DRB Agenda - Tuesday, September 19, 2023, 5:00 PM,

TO: Development Review Board
FROM: Garret King
DATE: September 19, 2023
RE: ZPF-23-63; 16 South Winooski Avenue

To: Development Review Board
From: Mary O'Neil, AICP, Principal Planner
Date: September 19, 2023
RE: 15 Hayward Street, ZP-23-298

To: Development Review Board
From: Mary O'Neil, AICP, Principal Planner
Date: September 19, 2023
RE: ZP-23-98; 41 Kingsland Terrace

(c) Clear Sight Triangle

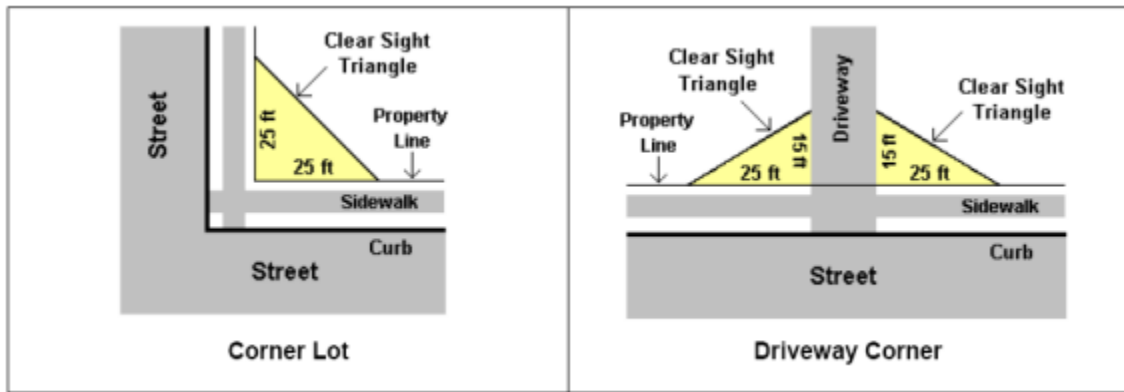
The fence layout obeys the clear sight triangle requirements for both the corner of South Winooski Avenue and Pearl Street intersection as well as the requirements for a clear sight triangle for the driveway. **(Affirmative Finding)**

(b).(v).(A) Fences and free standing walls

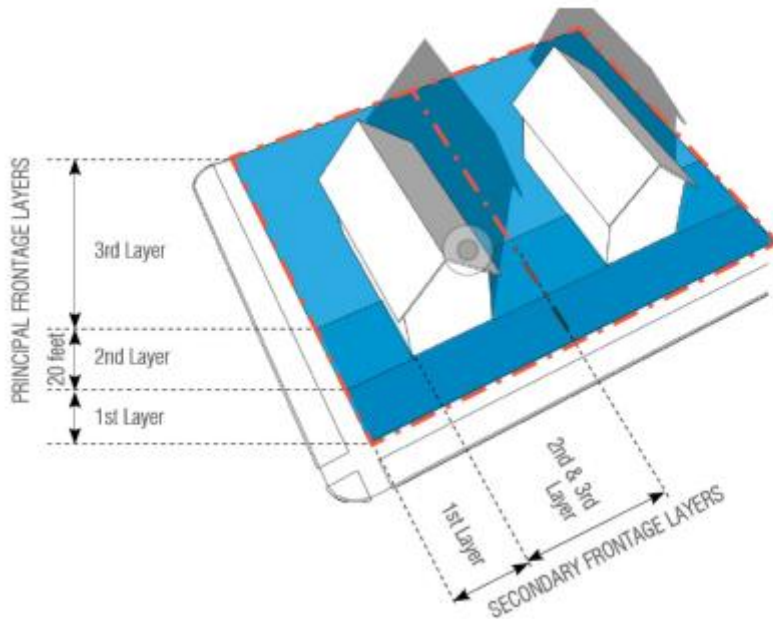
Fences and Free-standing Walls placed within the First Lot Layer shall not exceed 4-feet in height unless the applicant is seeking alternative compliance. See Sec. 14.7.3 b. **(Affirmative Finding)**

(a)Protection of Important Natural Features:

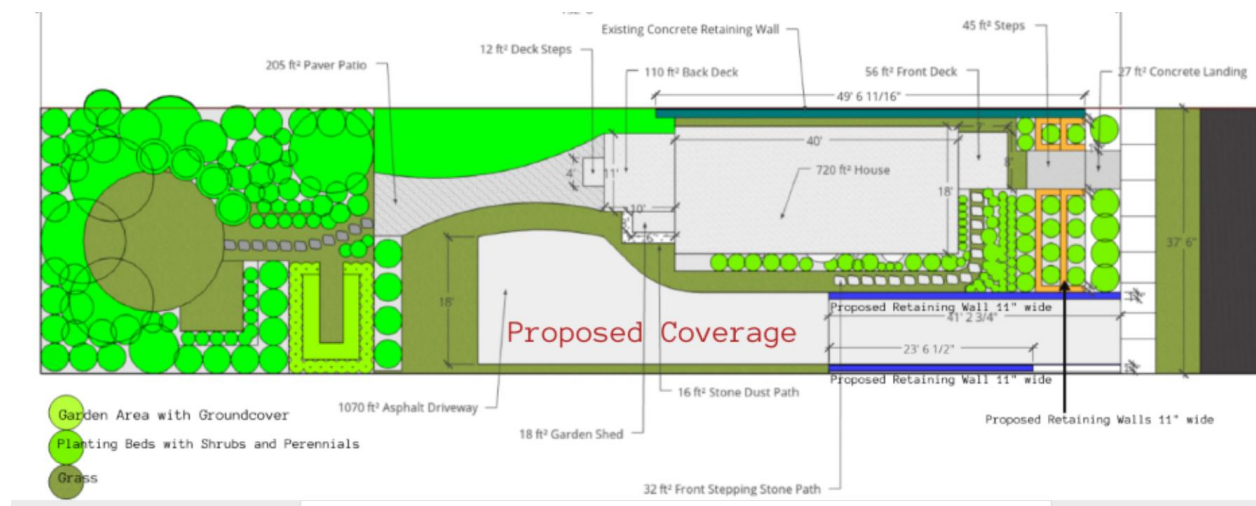
The driveway will be replaced in roughly the same dimensions as an earlier approval; existing trees on the west of the site will be retained with significant landscaping will be added to the site.

(g) Provide for nature's events:

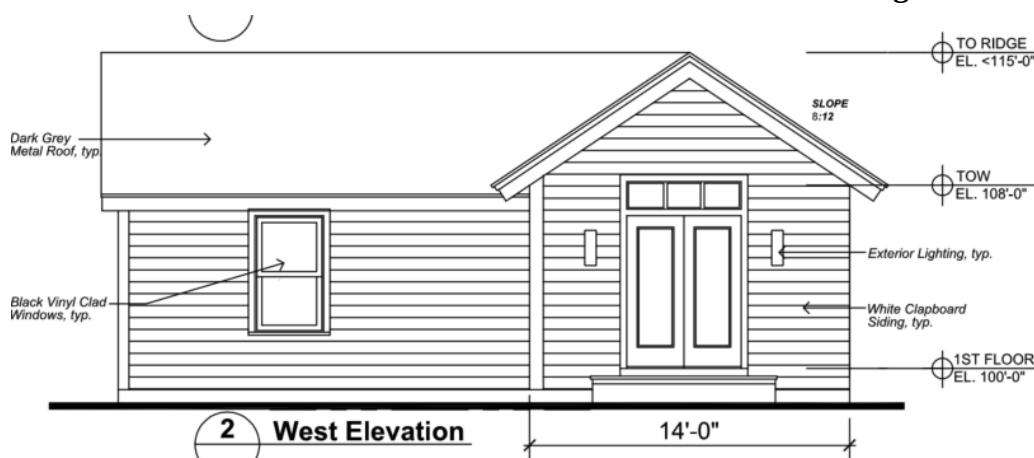
An Erosion Prevention and Sediment Control plan will be required.

The entrance to the ADU is on the west elevation (see below), which has no canopy or shelter over the door. Some form of shelter is recommended. **Affirmative finding as conditioned.**

(h) Building Location and Orientation:

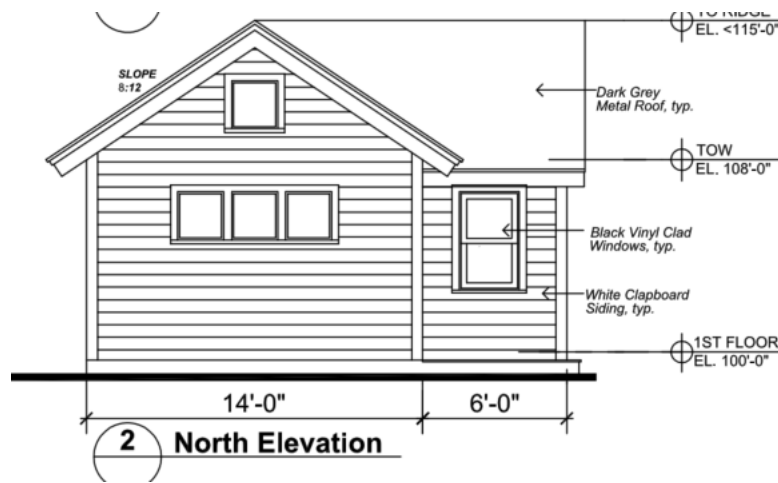
The ADU will be located in the approximate location of the existing garage. The streetfront elevation (north) has a pleasant window arrangement, which still affords visual privacy for the bedroom within. **Affirmative finding.**
